Government of the District of Columbia

Department of Transportation

**CSX Virginia Avenue Tunnel
Vibration Monitoring Review**

DCKA-2016-C-0500

Exhibit 4. Broadband Building Façade Vibration (Event No. 5) – Provided by CSX

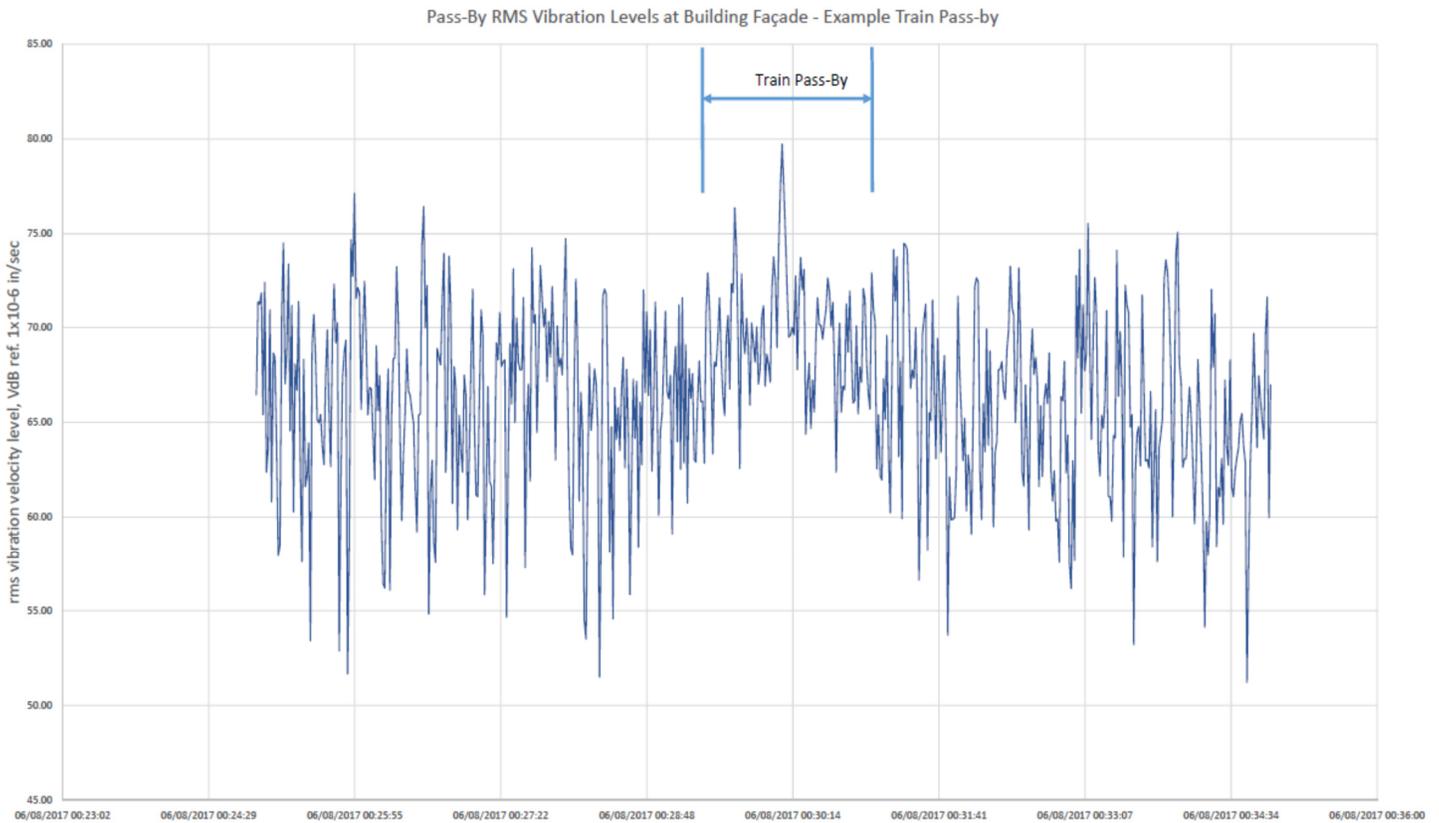
CSX provided two exhibits and a summary table of the supplemental data. This included a graph of broadband vibration over a 10-minute period during a train pass-by (Exhibit 4), a graph isolating train vibration for the same period (Exhibit 5), and a summary table of the 25

pass-bys captured by the supplemental study (Table 1). The graphs showed vibration data associated with Event 5 highlighted in Table 1. DDOT requested a written report of the findings of the supplemental monitoring, but CSX has stated that they will not prepare a formal report.

Exhibit 5. Isolated Train Pass-By Vibration – Building Façade Vibration with Tunnel Slab Vibration (Event No. 5) – Provided by CSX

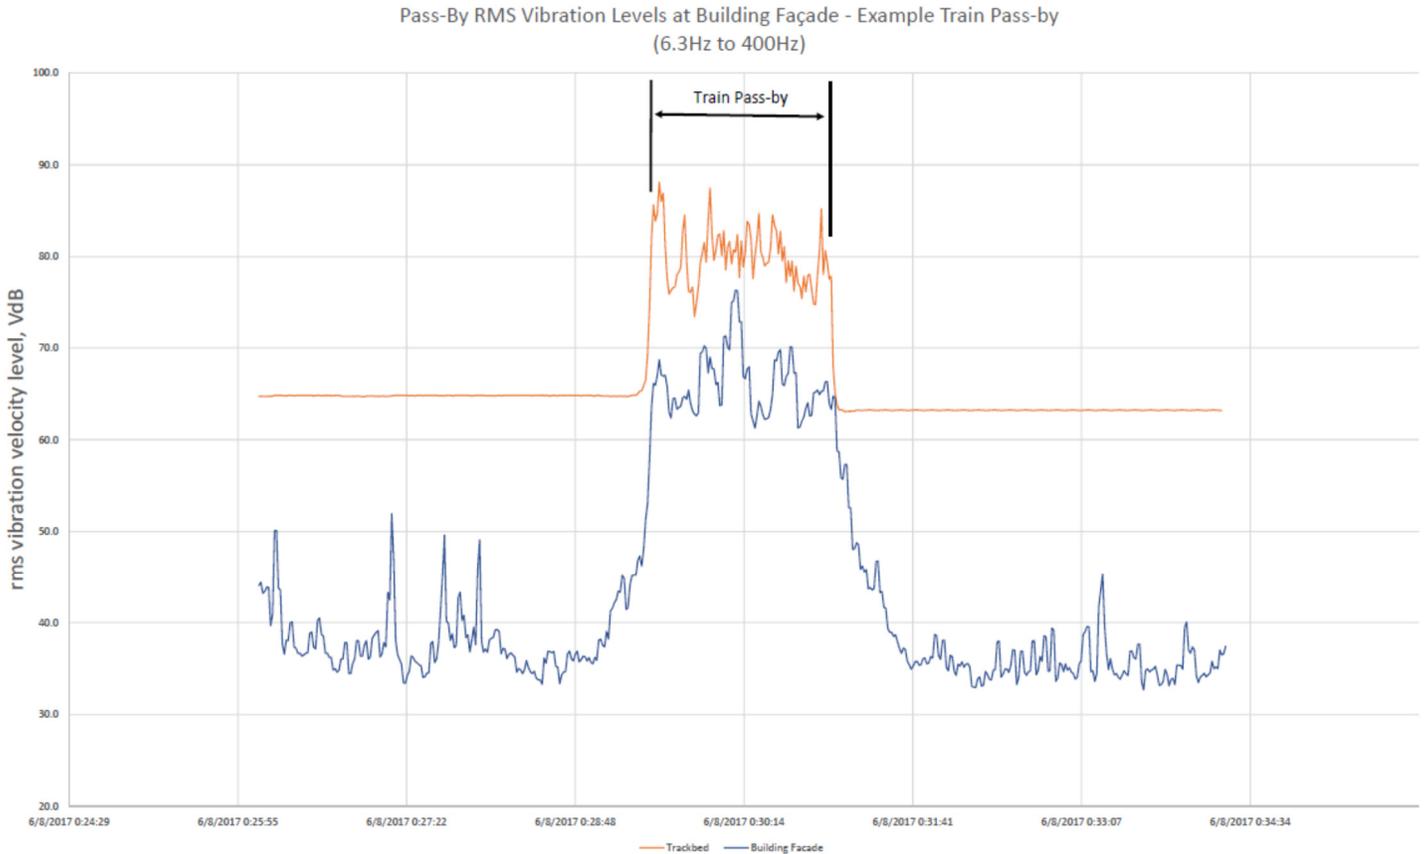
Table 1 summarized each of the recorded pass-bys at the building façade. The reported vibration levels were averaged over the locomotive pass-by and over the rail car pass-by. CSX did not report maximum vibration levels during pass-by events. The FTA Manual is not clear on whether maximum or average values should be reported. Average vibration during the rail car pass-bys ranged from 54 VdB to 68 VdB. Average vibration during the locomotive pass-bys ranged from 59 VdB to 71 VdB. These levels did not exceed the FTA vibration limits of 80 VdB identified in the EIS. The rail car vibration also did not exceed the 75 VdB limit that is appropriate for Occasional Events as described in Section 3. However, several measurements do exceed 65 VdB, and would likely be perceptible by residents.
